Nic Clyde

26 August 2025

Metropolitan Coal Mine - Longwalls 317 and 318 Modification (MP08_0149-Mod-4)

Figure 1: Metropolitan Coal Mine Scope 1 emissions: Clean Energy Regulator data (FY17-FY24) vs Metro Mod 4 projections for 'Modification Scenario'

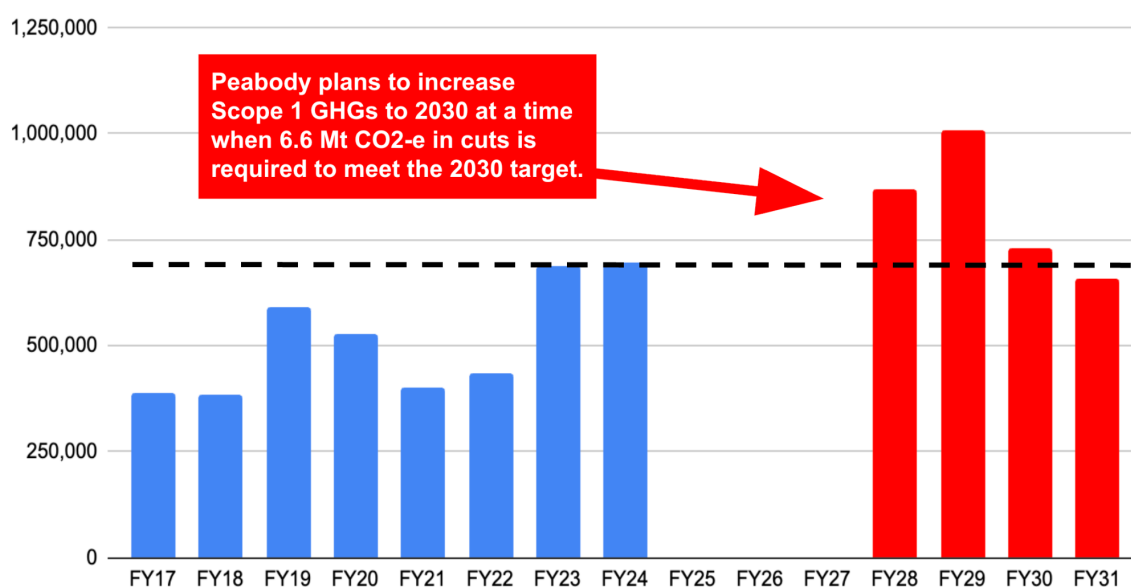
Without this modification, Peabody expects that the Metropolitan Coal Mine would “cease operations in 2029”.⁵ With the modification, coal mining would continue to coal extraction “until approximately 30 June 2031”. If mining were to cease in FY29, this would mean that most of the 730,000 t CO₂-e of Scope 1 emissions predicted for FY30 would be avoided. Given that NSW DCCEEW currently predicts that NSW will be 6,600,000 t CO₂-e over where the state’s GHG inventory needs to be in 2030, a reduction of ~730,000 t CO₂-e would be material. It would represent 11% of the abatement required to meet the 2030 target.
